Agenda  
Lane Cove Local Planning Panel Meeting  
15 June 2022

**Lane Cove Local Planning Panel Meeting 15 June 2022  
72 KALLAROO ROAD, RIVERVIEW**

**Subject:** 72 Kallaroo Road, Riverview  
**Record No:** DA22/18-01 - 15216/22  
**Division:** Environmental Services Division  
**Author(s):** Greg Samardzic

**Lane Cove Local Planning Panel Meeting 15 June 2022  
S 4.55 AT 2 - 4 MERINDA STREET LANE COVE NORTH**

**Figure 18: Applicant's FSR Calculation Diagrams**

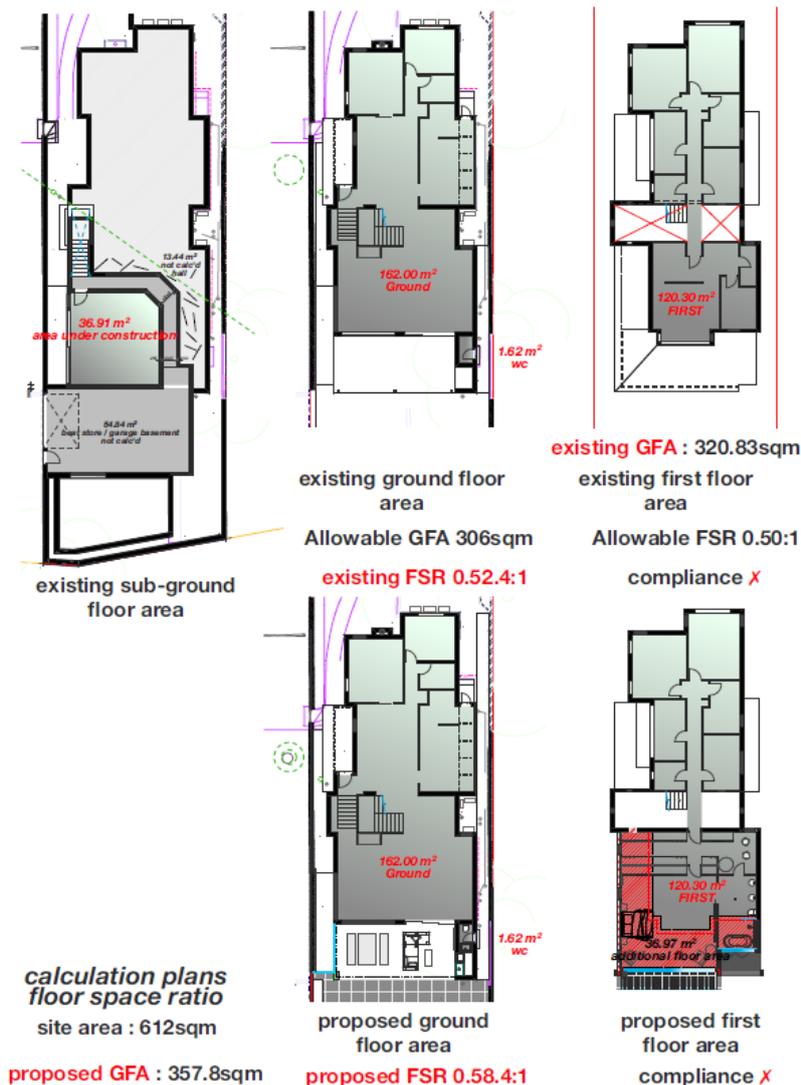
The proposed alterations and additions which are the subject of this application seeks to further increase the floor space of the dwelling by 36.97m<sup>2</sup> to enable necessary changes to be made to the existing first floor plan in the rear half of the dwelling to improve the amenity of the master suite, ensuite and walk in robe/dressing room. A review of the approved delegated report has indicated that the approved FSR was 0.58:1 (355m<sup>2</sup>) which would mean that the proposed FSR would be at least approximately 0.64:1 as Council had counted parts of the basement level as floor space in addition the floorspace created by the media room. However, if one counted all the applicant's excluded areas, the maximum FSR would be approximately 0.69:1 Please see the applicant's method of calculation below:

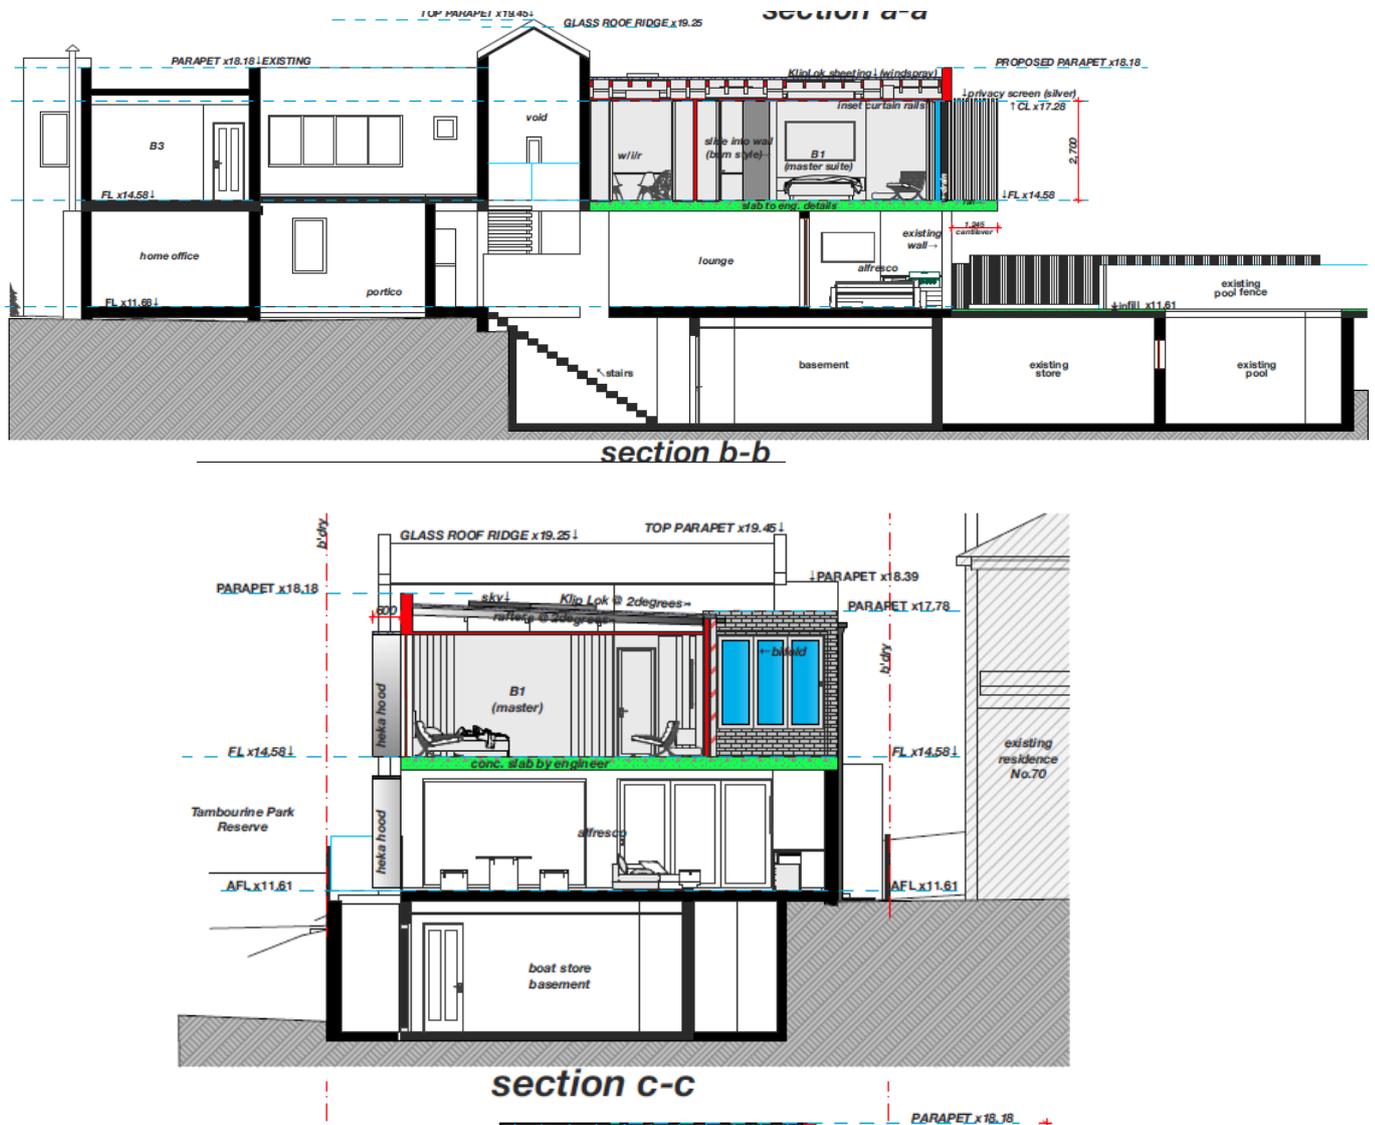
The submitted architectural drawings does not adequately demonstrated whether the proposal complies with the maximum 9.5m Building Height development standard by not indicating where the natural ground levels and the maximum building height plane are. The drawings have been reviewed with respect to the definition of Building Height contained within Lane Cove Local Environmental Plan 2009 being:

Whilst the applicant has claimed full compliance however Council's assessment has indicated that when you measure the highest point of the proposed addition from top of the parapet to the bottom of the basement level which is now the natural ground level, the maximum height is proposed is 9.7m when measuring off the submitted section plans.

**Figure 21: Proposed Roof Plan of the New Works Adjacent to the Existing Adjoining Dwelling**

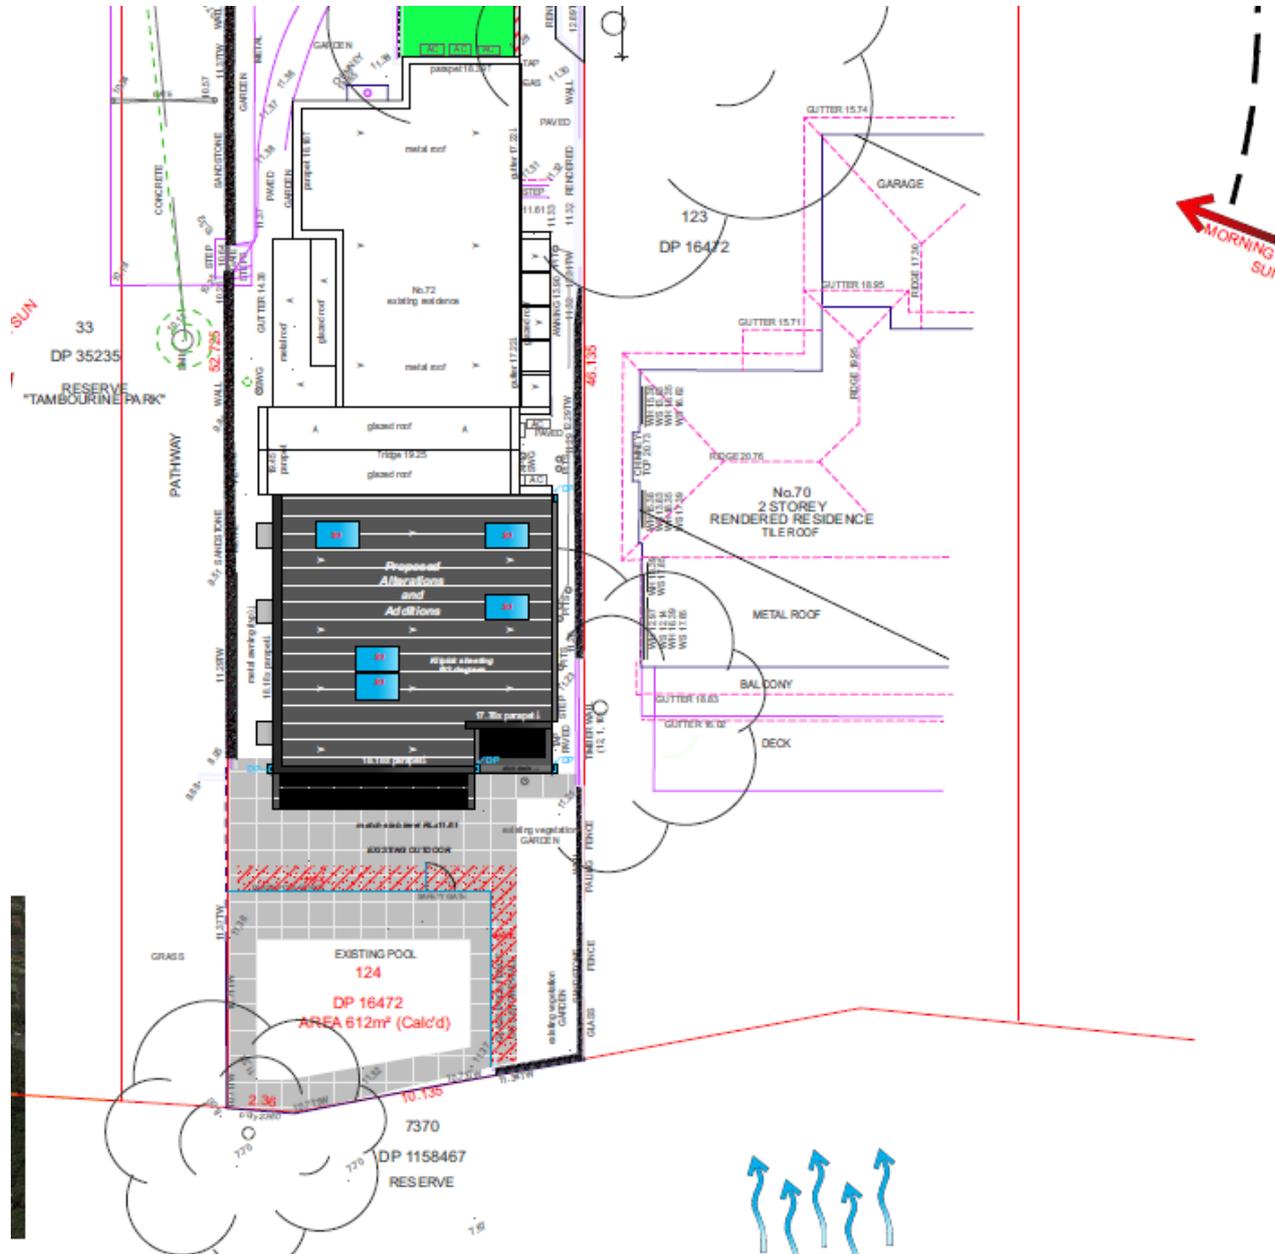
**ii. Rear Setback** – The DCP requires a minimum 12.4m rear setback. The proposed alterations and rear addition to the first floor would have a rear setback of 8.675m on the eastern boundary and

10.475m on the western boundary. It is noted that the existing rear setback of both the ground and first floors matches the existing setbacks of the dwelling to the east and the proposed upper level addition including new balconies would now be well forward of the existing ground level deck and well forward of the upper level including the balcony of the adjoining dwelling.

Along with the above side first floor setback variation, this variation also contributes to the concerns posed by the large FSR variation involved being the overdeveloped nature of the proposal by not maintaining a consistent rear setback with the adjoining dwelling and reasons provided above under the side setback variation section of this report.

Figure 4: Proposed extension to rooftop terrace area.

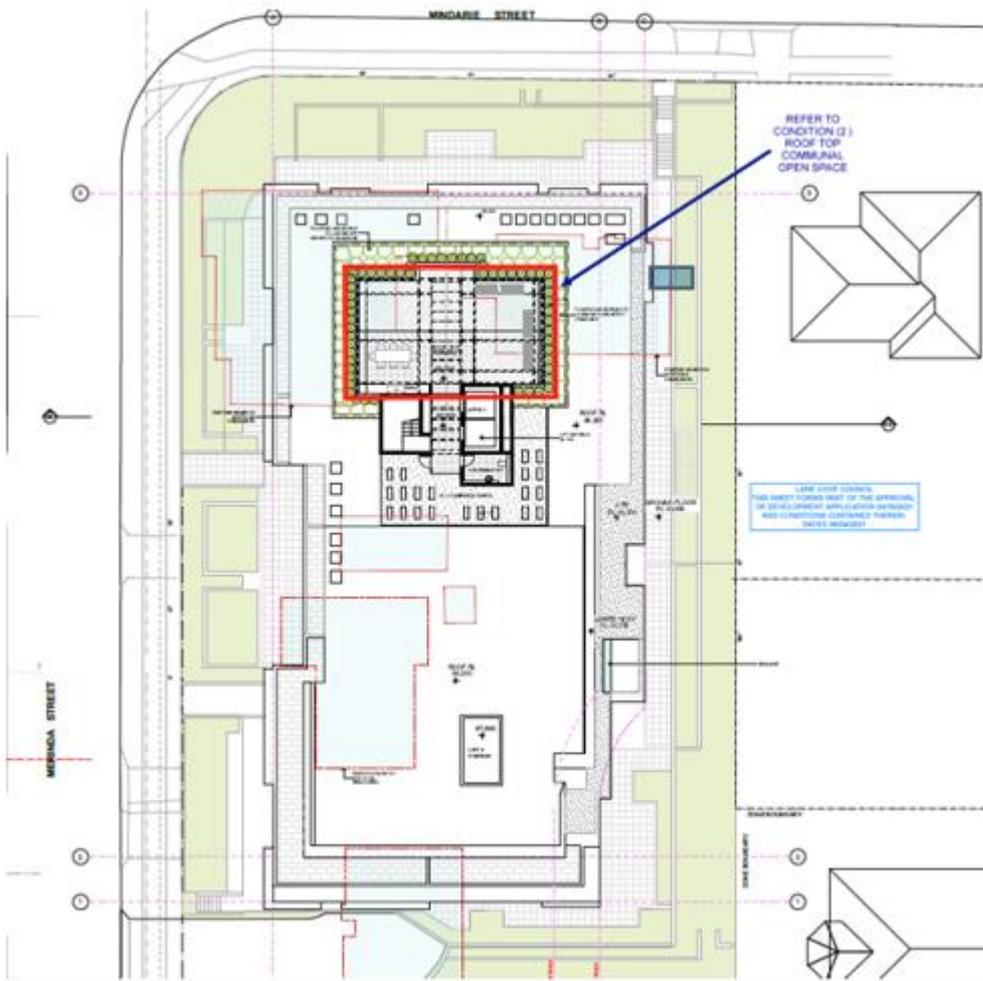
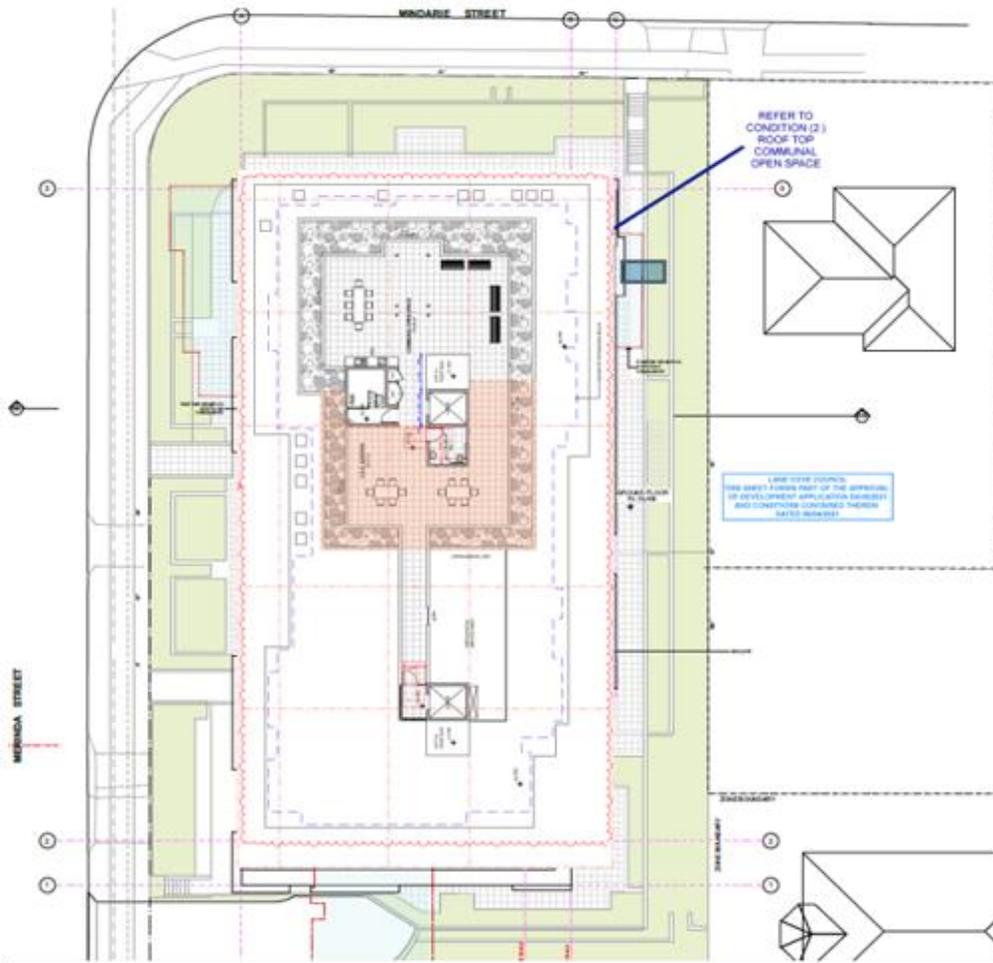
1. (a) *The proposed roof top communal open space is to be increased in area by approximately 70% of its current size. The increased size shall not create any impacts on privacy of adjoining properties.*
2. (b) *The amended communal area is to include a planter box around the perimeter. The adjacent rooftop service area will be required to be rearranged to suit. The amended area must not include any feature which exceeds the 17.5m height limit and must not involve movement or alteration of the existing features of the rooftop communal area that are the subject of the cl4.6 request, namely the pergola, lift overrun 1, accessible WC roof, fire stairs roof and lift overrun 2.*

Figure 6: Proposed works above 17.5m height control (pink layer).

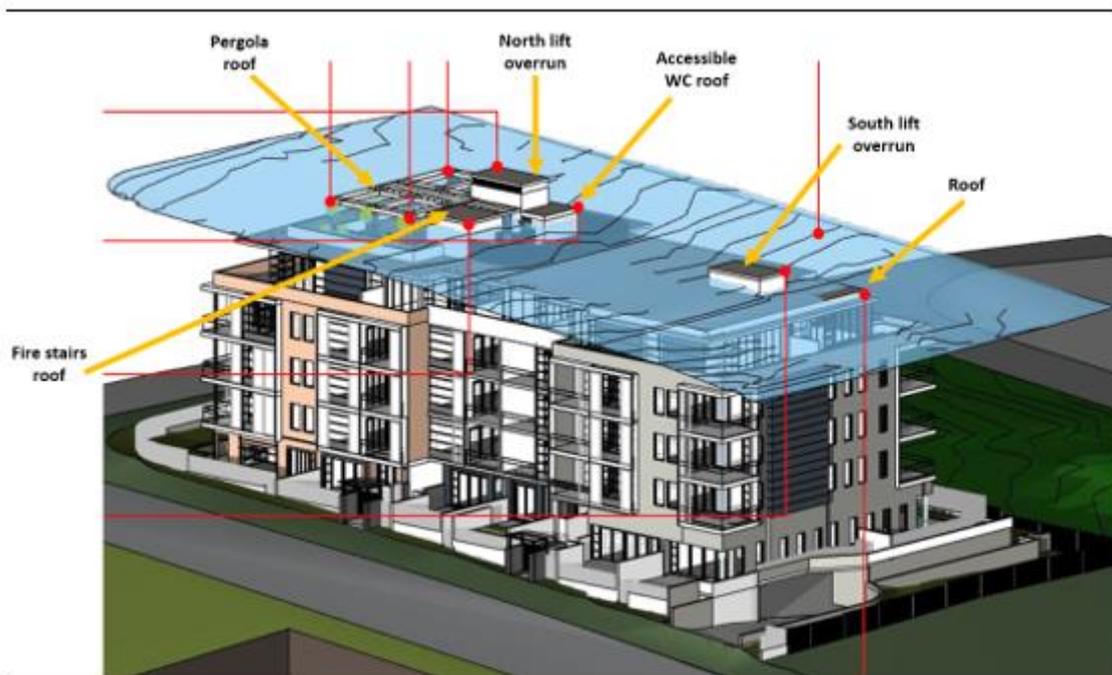
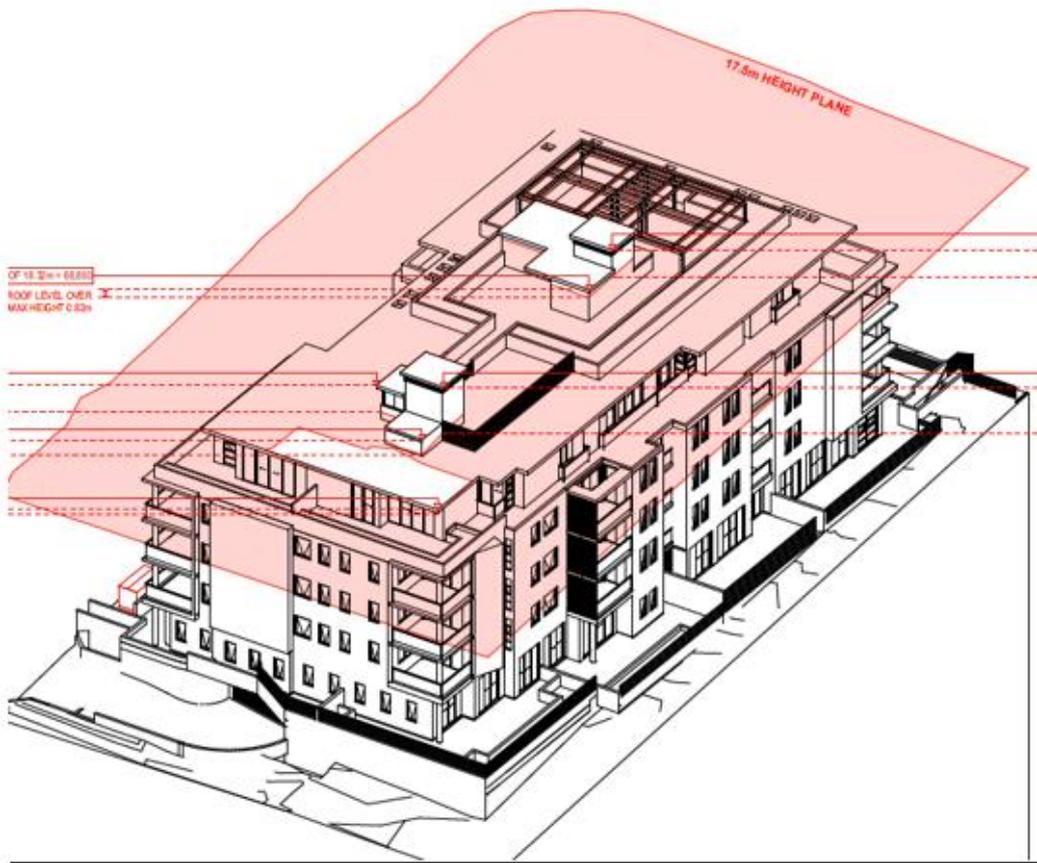
- The approved building has a maximum building height of 20.044m (2.544m or 14.6% variation) to the northern lift overrun.
- The s4.55(2) modifications propose a maximum building height of 21.29m (3.79 m or 21.6% variation) to the southern lift overrun.

Figure 9: Distance from rooftop terrace to nearest single dwellings.

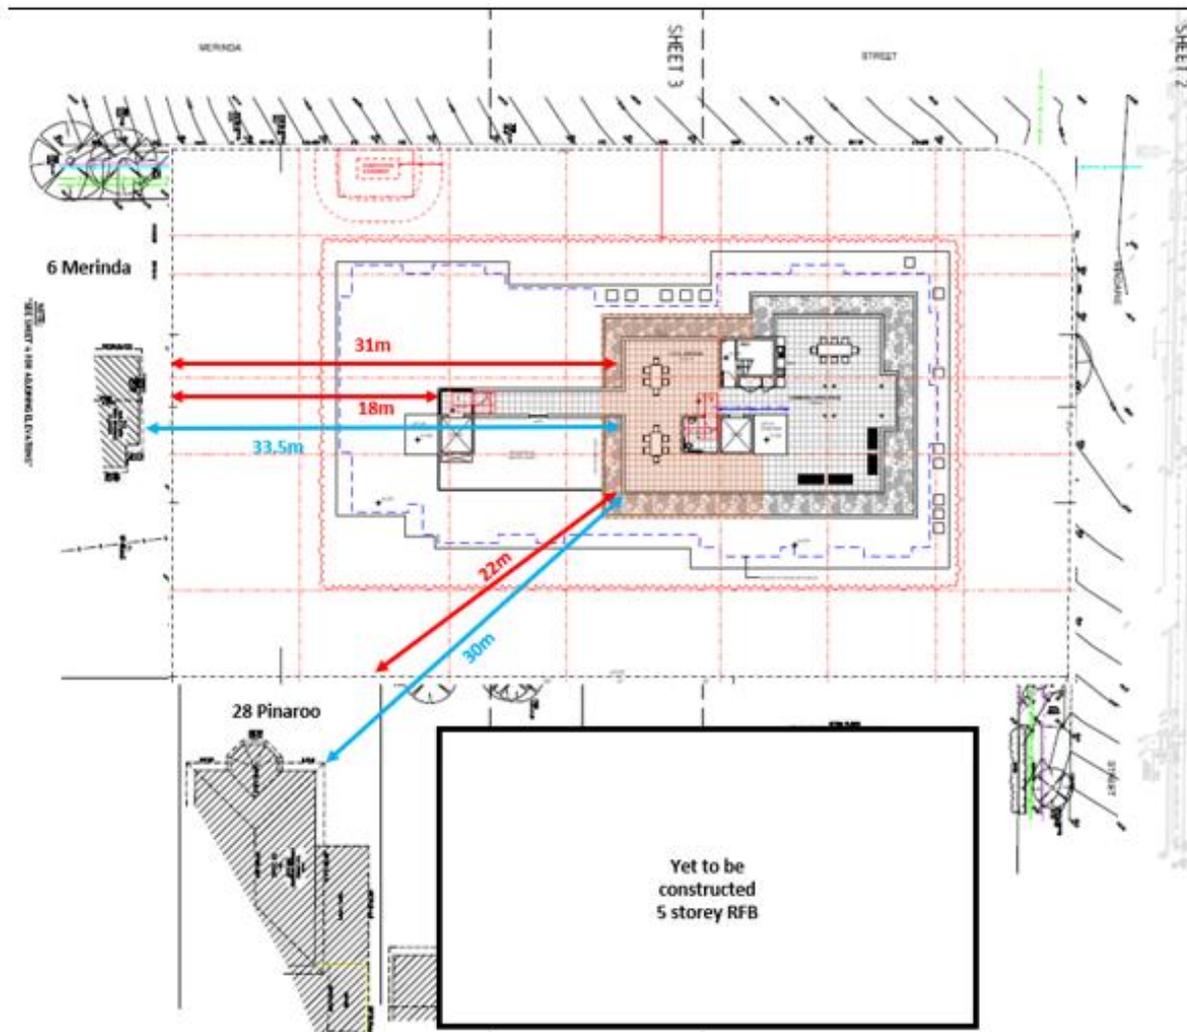
<p>dwelling houses. Views will largely be over the roofs of these dwellings.</p> <p>The large separation of the extended roof top communal area is not considered to result in unreasonable acoustics or visual privacy impacts.</p>	
<p>3.14 Solar Access</p> <p>(c) Where adjacent dwellings and their open space already receive less than the standard hours of sun, new development should seek to maintain this solar access where practicable.</p> <p>(d) Council may accept a reduction in solar access for the subject site and adjacent development if the topography and lot orientation (as distinct from a preferred design) are such that the standard is considered unreasonable.</p>	<p>The approved development included compliant building separation, and further separation at the upper-storey to reduce total shadows. The setbacks were increased by an additional 3m to accommodate the zone transitions</p> <p>The s4.55 modification includes some additional roof top elements which exceed the 17.5m height control.</p> <p>The applicant has provided updated shadow diagrams from 9.00am through to 3.00pm in midwinter.</p> <p>The diagrams confirm:</p> <p><b>9.00am:</b> Additional shadows on Merinda Street carriageway, the front footpath, and setback of the (Hyecorp) residential flat building at 1 - 7 Merinda Street</p> <p><b>10:00am:</b> Additional shadows to front footpath/yard and roof of 10 Merinda Street. (No impacts to open space or north facing windows)</p> <p><b>11:00am:</b> Additional area shadows fall on roof of 10 Merinda Street (potentially additional shadows on northern elevation/windows)</p> <p><b>12:00pm:</b> Additional area shadows on side property boundary of 10 Merinda Street and 8 Merinda Street (adjacent to pool patio) – majority of rear yard receives full solar access. Small area of shadow on the roof of 28 Pinaroo Place.</p> <p><b>1:00pm:</b> Additional area of shadows on rear yard of 26 Pinaroo Place. – However majority of rear yard receives solar access at 1.00pm.</p> <p><b>2:00pm:</b> Additional area of shadows on rear yard and roof of 26 Pinaroo Place. Approx. 50% of rear yard still receives full sun.</p> <p><b>3:00pm:</b> Additional shadows on front yard of 24 Pinaroo Place, Council footpath and street in front of 24 Pinaroo Place.</p> <p>The LEP controls permitted a 5-storey RFB to be approved on the site. The site</p>	<p>YES</p>
